**RE: South Winds Development Co. Inc. (Edgewater Estates Subdivision) Application for Redline Amendment to Draft Plan of Subdivision 39T-MC0902 and Zoning By-law Amendment ZBA 26  
OUR FILE 08237 A**

This letter is being submitted on behalf of South Winds Development Co. Inc. ("South Winds") and in response to the post circulation comments that were circulated on February 19, 2019 and March 6, 2019 with respect to the above noted applications. The redline revisions and zoning amendment applications were submitted on October 29, 2018 and the Public Meeting was held on January 23, 2019.

MULTI-USE TRAIL LOCATION

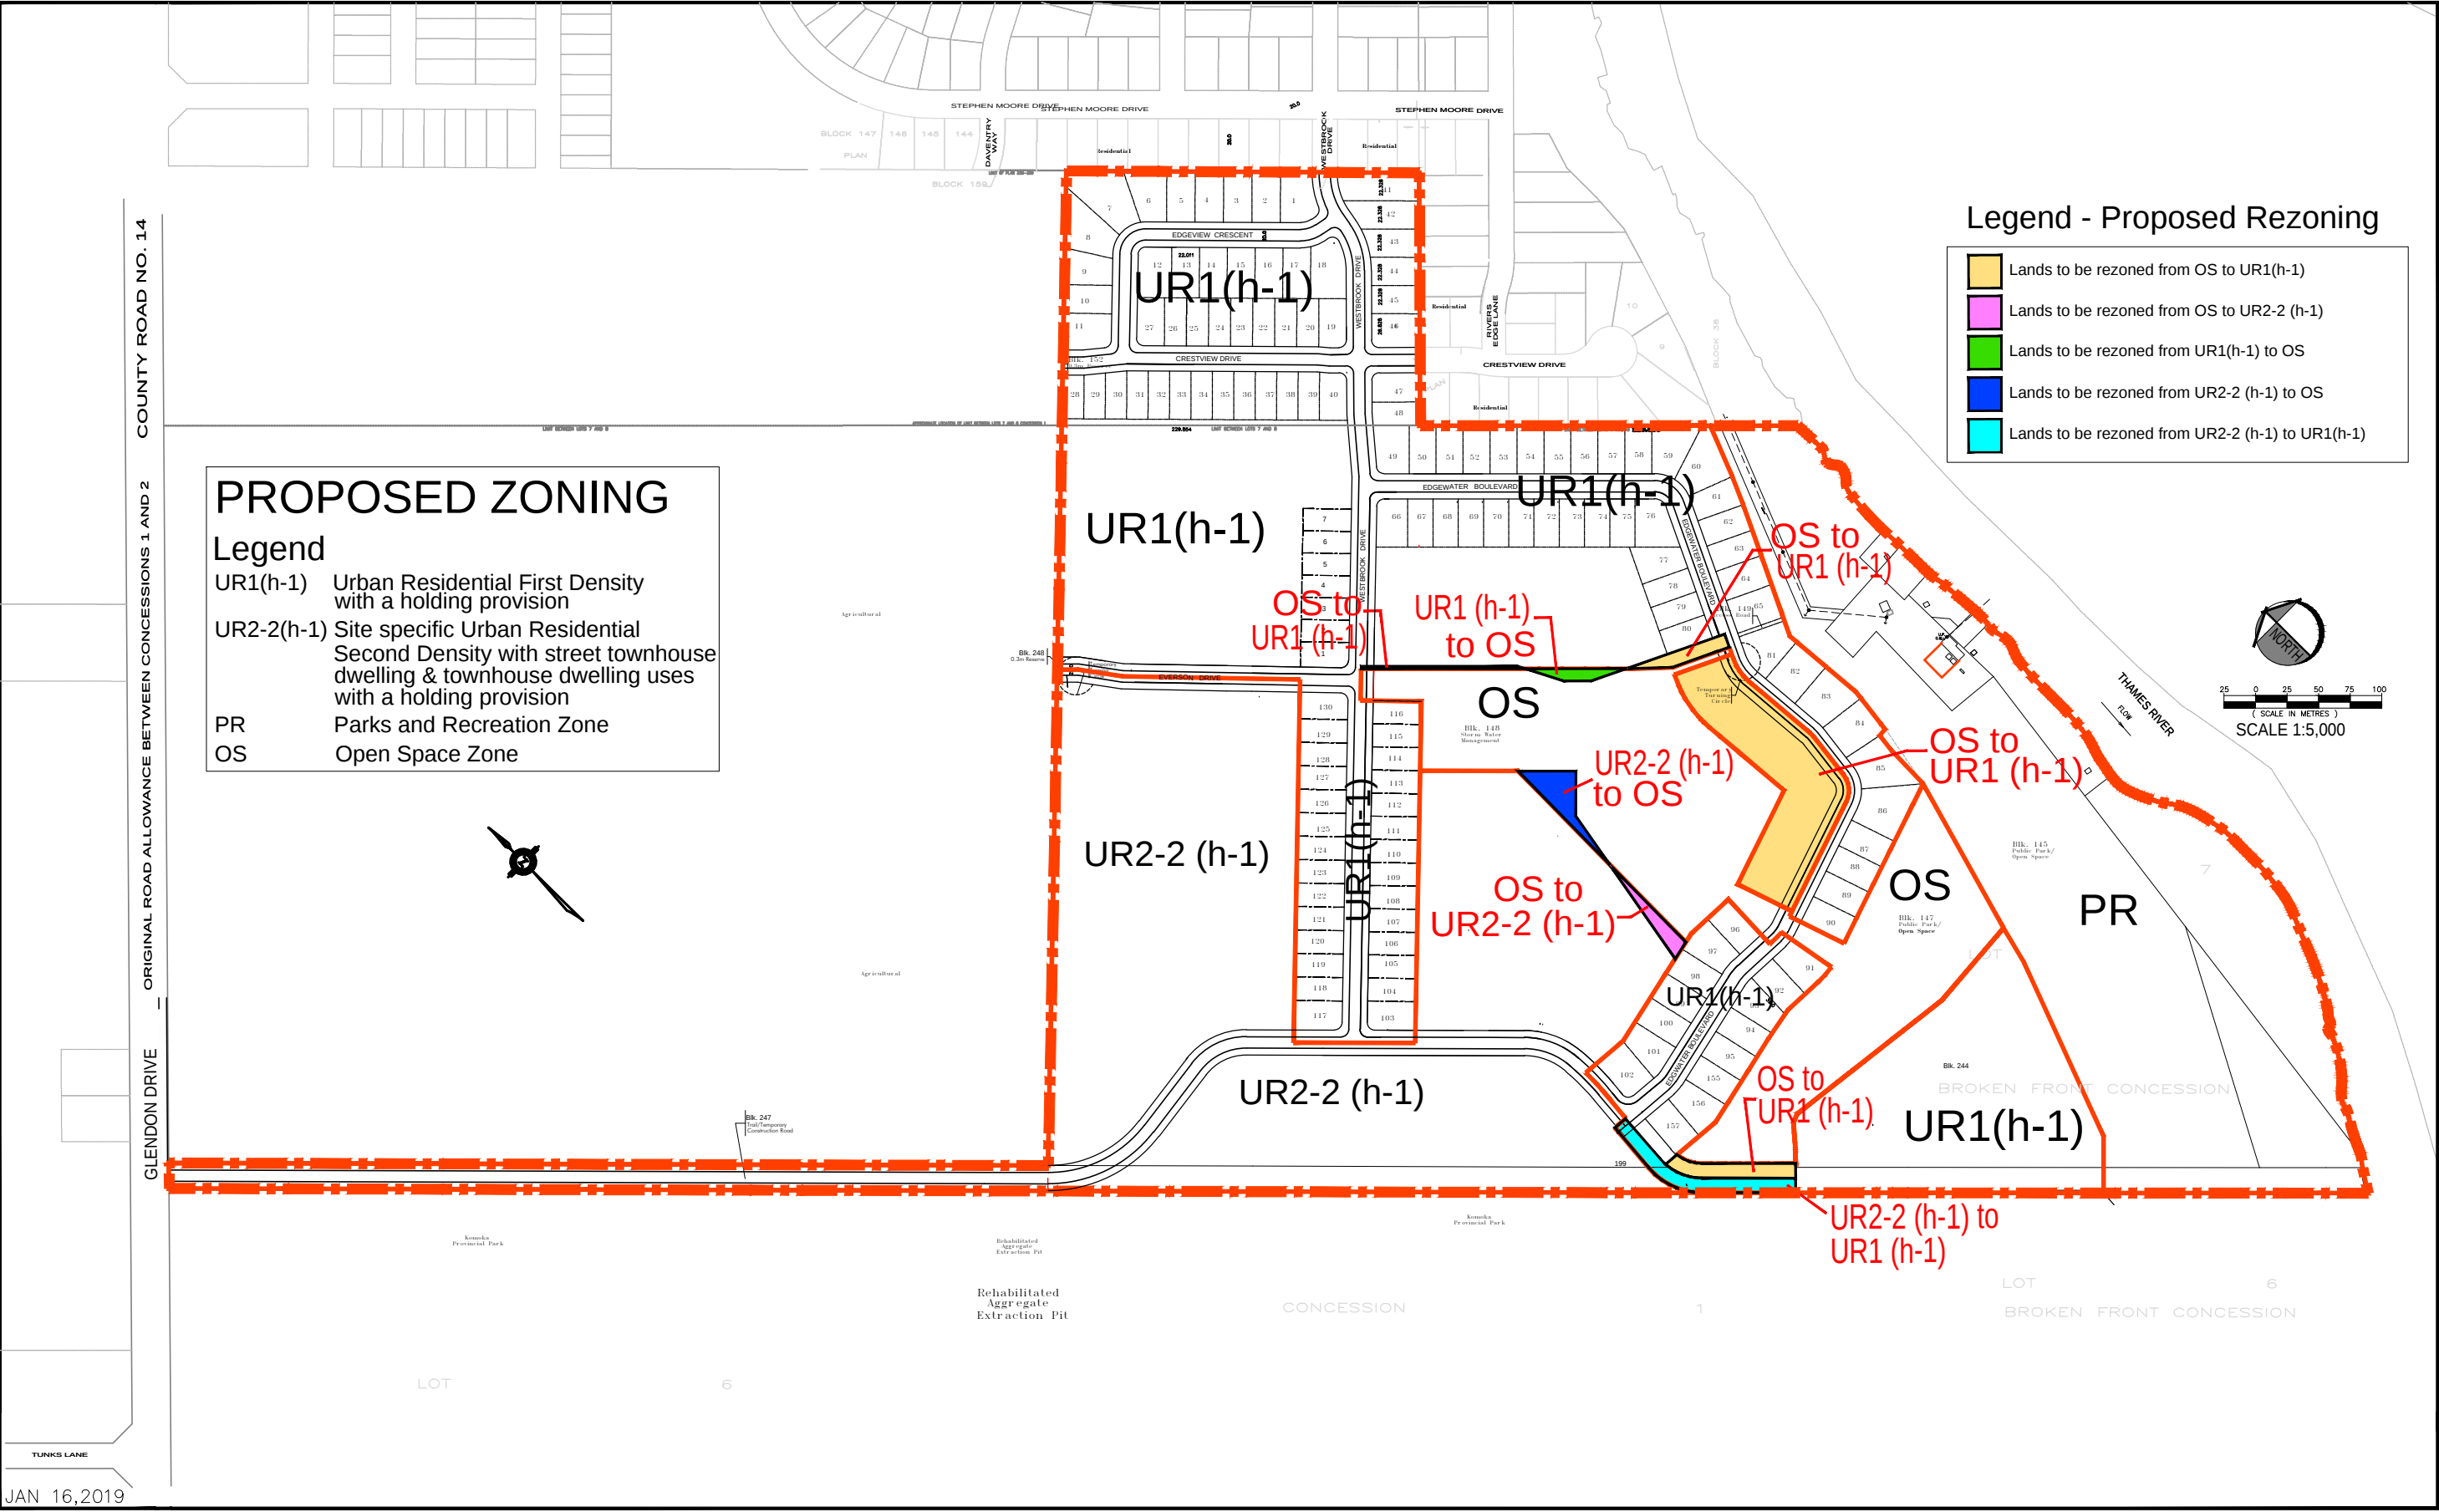
*It is our hope that these redline revisions will complement our development to the North of this site. Our main concern is on the changes to the multi-use pathway, and ensuring that the function and intent of the trail is upheld. We recognize that the request is to change the road from a public to a private road, and this is the road that the multi-use trail ran along. We see the Multi-Use Trails as an attractive and important amenity for both sites and want to ensure that it is properly tying into the natural features of the area so that it remains a desirable amenity for the community. We are worried that if the trail merges with the road and runs along the streetscape it will be less desirable than if it ran along a naturalized area. We would like a further understanding and detail of how the trail will be planned and the intent of the multi-use trail will be upheld.*

The modifications proposed through these redline revisions result in minimal changes to the location and function of the multi-use trail. The attached plans show the previously approved route through the Edgewater Estates subdivision which follows along Edgewater Boulevard and Street 'B' up to Glendon Drive. A walkway connection to the Thames River is shown in the southern part of the plan opposite the walkway running through the SWM pond.

The current route is shown in the same general location. The main difference is that the Street "B" road connection to Glendon Drive has been replaced with a multi-use trail only. The layout of Edgewater Boulevard within the subdivision was revised to accommodate the removal of the road connection to Glendon Drive which was requested by Middlesex Centre and the County of Middlesex. The previous alignment of the road is shown in a dashed line. The walkway connection is in the same location as it enters the subdivision and will run alongside Edgewater Boulevard in a similar manner to the draft approved plan. The walkway connection to the Thames River is also in the same location as to what is shown on the draft approved plan.

In summary, the multi-use trail has always been shown adjacent to Street "B" and Edgewater Boulevard. As noted, the Approval Authority(s) required South Winds to remove the Street "B" road connection to Glendon Drive. As a result, that section of the multi-use trail that generally runs alongside the provincial woodlot will no longer be adjacent to Street "B". In our opinion, this is a net improvement to the design of the trail.
